Project: PRA-ROCR 10(5)
The purpose of this Amendment is to:

Amendment No. 0002
Project PRA-ROCR 10(5)
Rock Creek Park
Solicitation: DTFH71-16-R-00001

Project Name: Beach Drive from Rock Creek Parkway to Maryland State Line

AMENDMENT NO. 2 ◇1	PMIS NO.	NPS NO.	STATE	PROJECT	SHEET NO.
	044965	821 / 100425	DC	PRA-ROCR 10(5)	D54

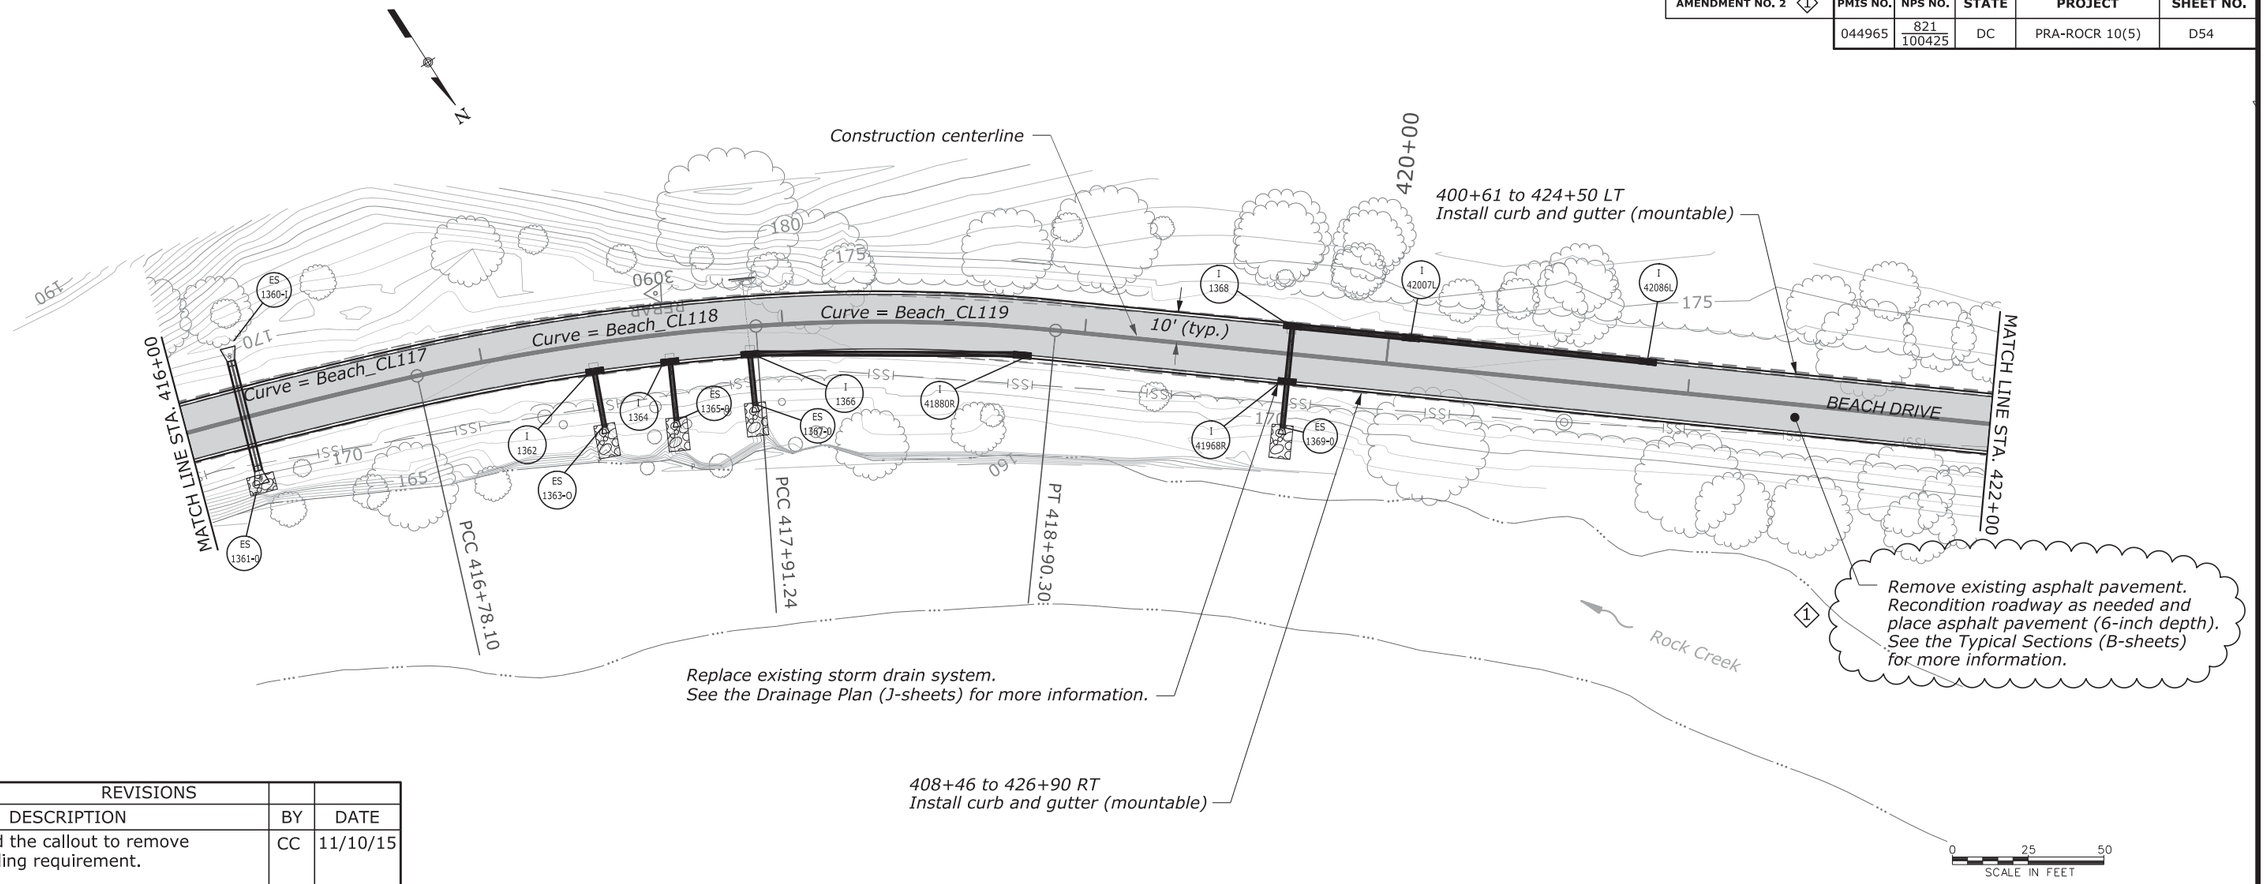
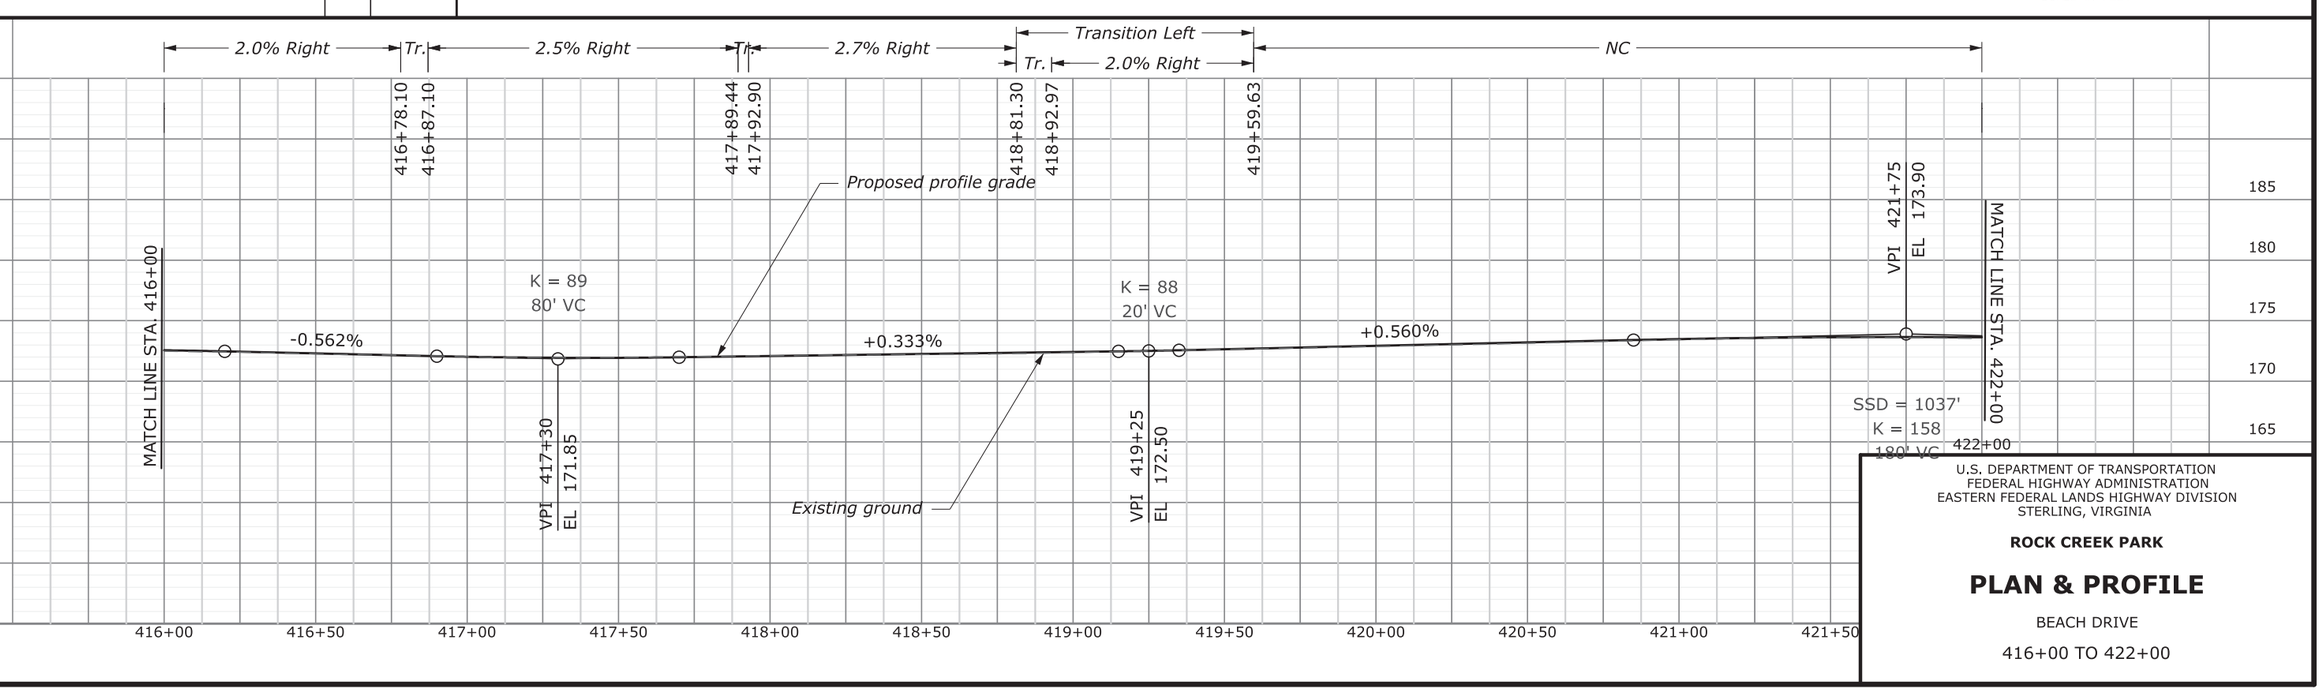
REVISIONS			
NO.	DESCRIPTION	BY	DATE
◇1	Revised the callout to remove the milling requirement.	CC	11/10/15

AMENDMENT NO. 2 ◇1	PMIS NO.	NPS NO.	STATE	PROJECT	SHEET NO.
	044965	821 / 100425	DC	PRA-ROCR 10(5)	D55

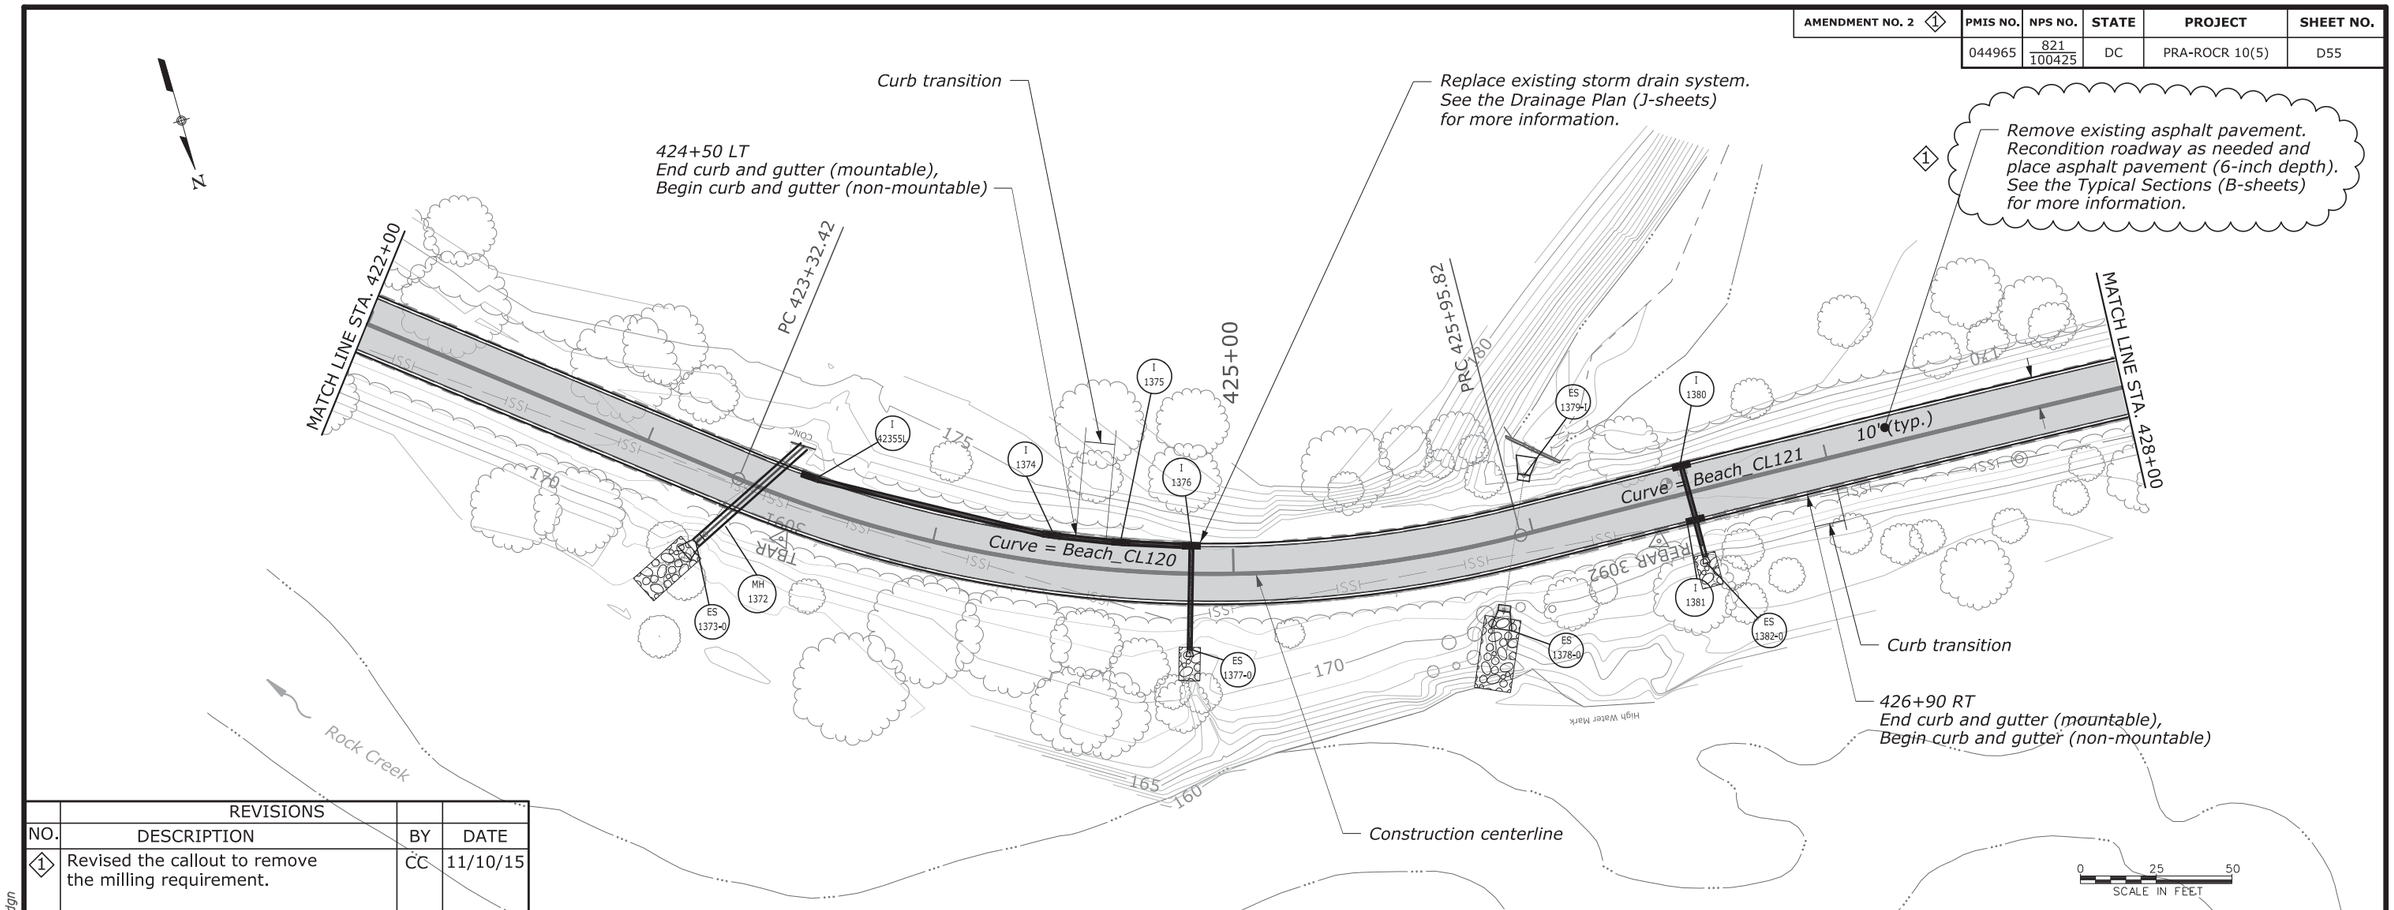
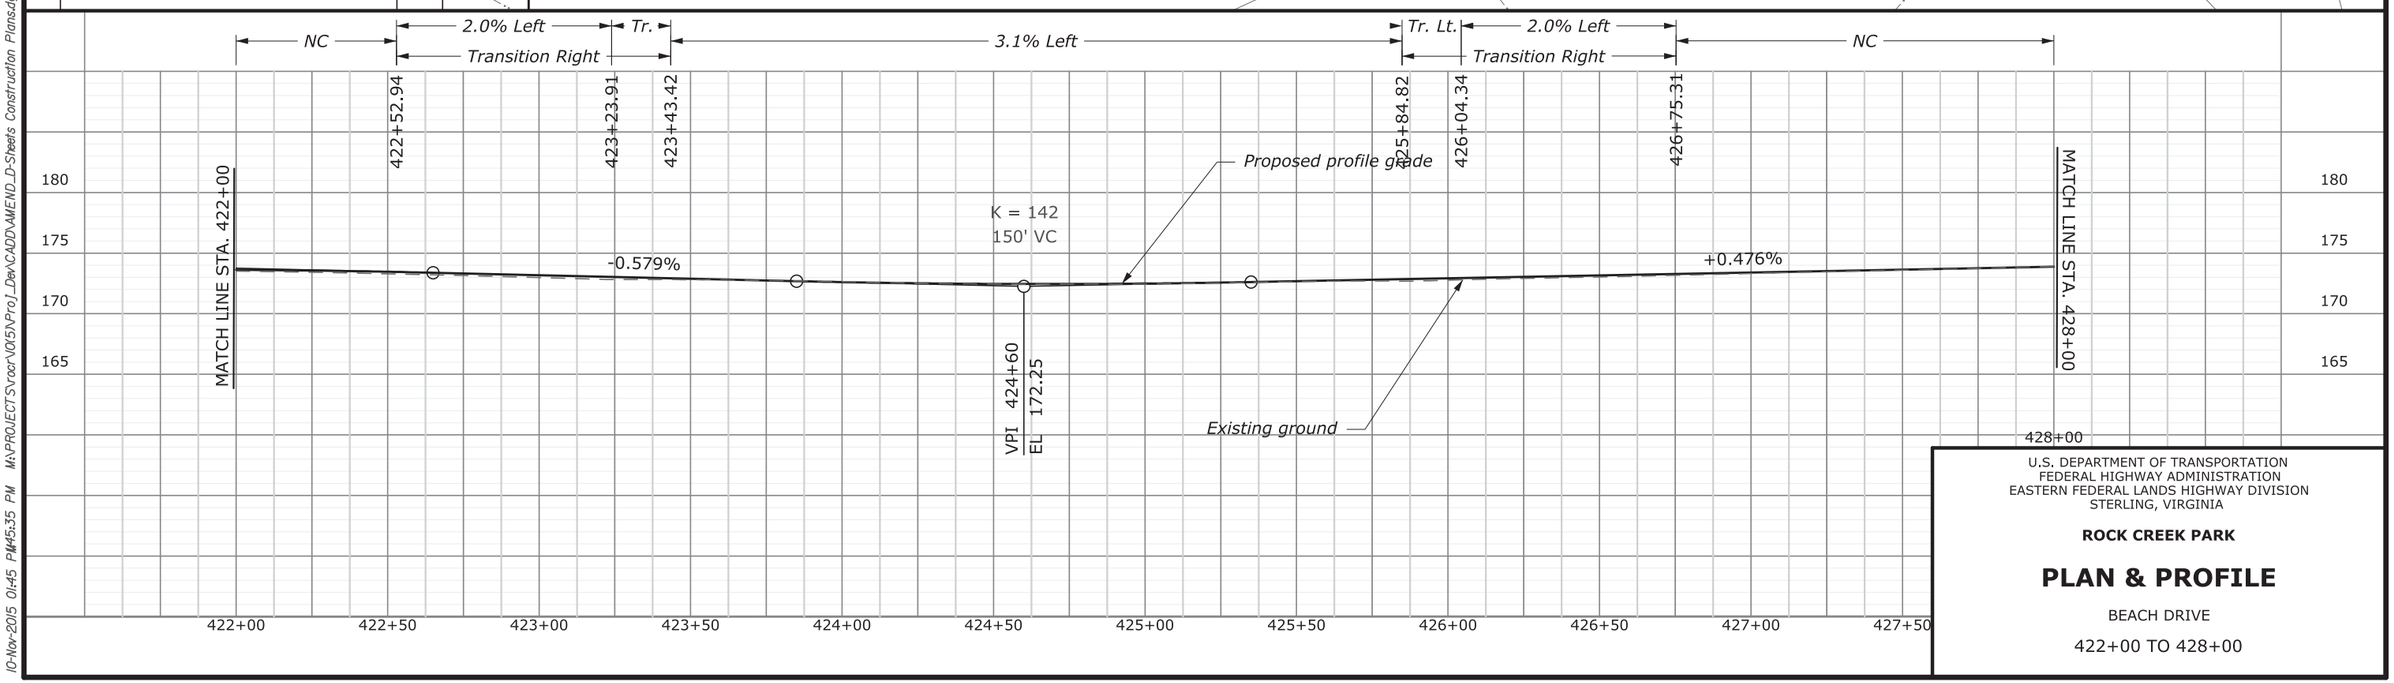
REVISIONS			
NO.	DESCRIPTION	BY	DATE
◇1	Revised the callout to remove the milling requirement.	CC	11/10/15

AMENDMENT NO. 2 ◇1	PMIS NO.	NPS NO.	STATE	PROJECT	SHEET NO.
	044965	821 / 100425	DC	PRA-ROCR 10(5)	D56

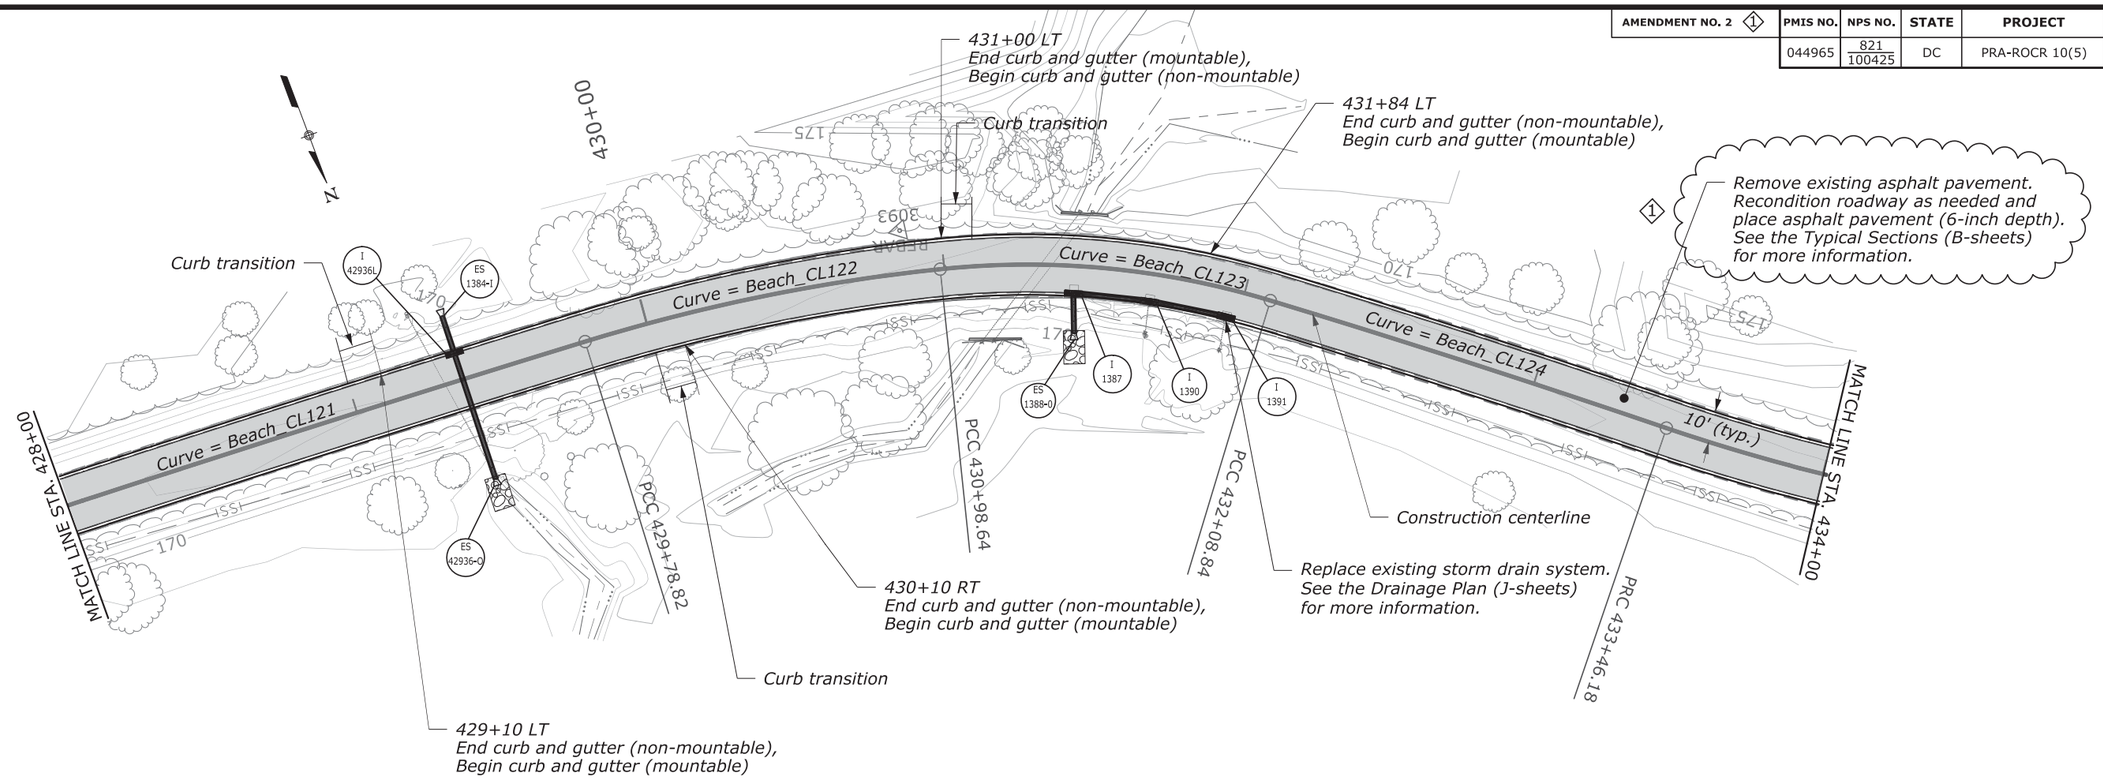
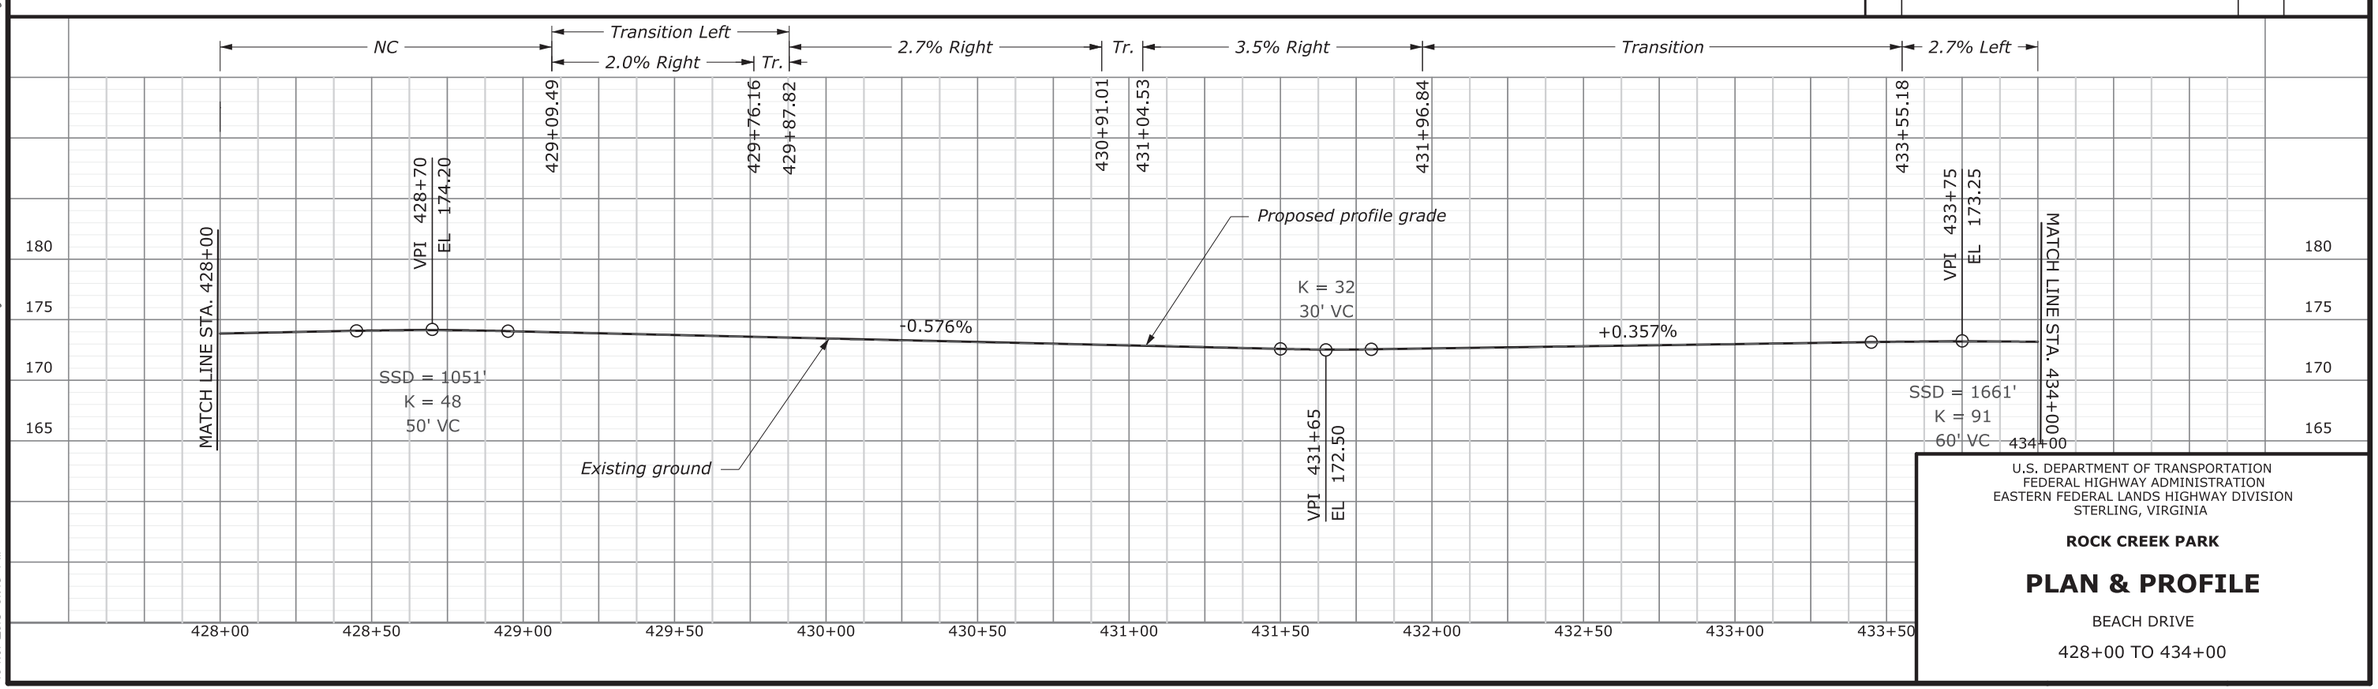
NO.	REVISIONS DESCRIPTION	BY	DATE
◇1	Revised the callout to remove the milling requirement.	CC	11/10/15
